Product Change Notice

FPC Series Chassis Change

Notification #: 2009070001

Affected Model: Listed Below

Comparison 1

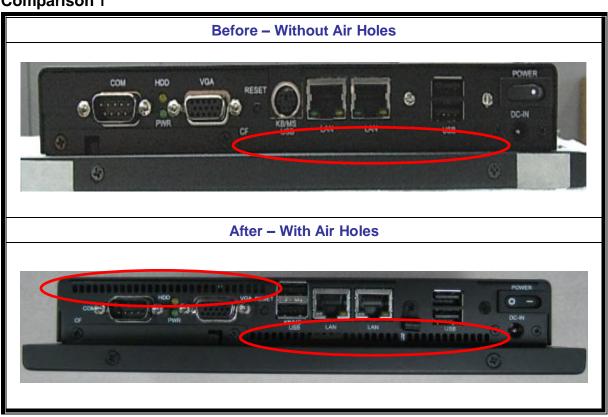
To provide the better thermal solution, a tiny modification of air holes is made on the rear I/O side of FPC-08W series. Meanwhile, have the printings of I/O modified for correcting and visible.

Comparison 3

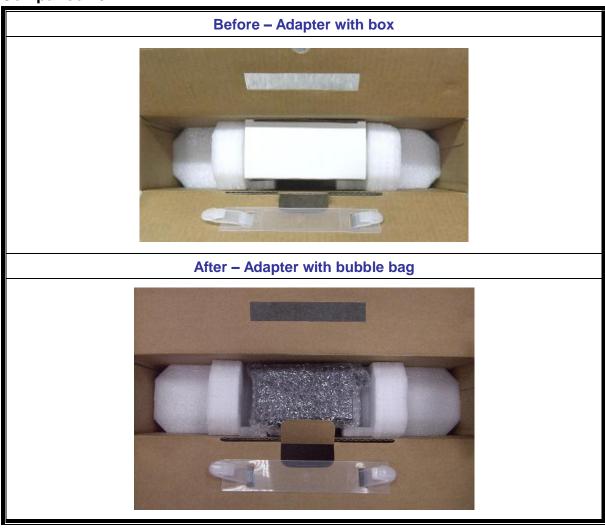
And, due to the change of adapter (PCN#2009040003), the packing of adapter will be different as well.
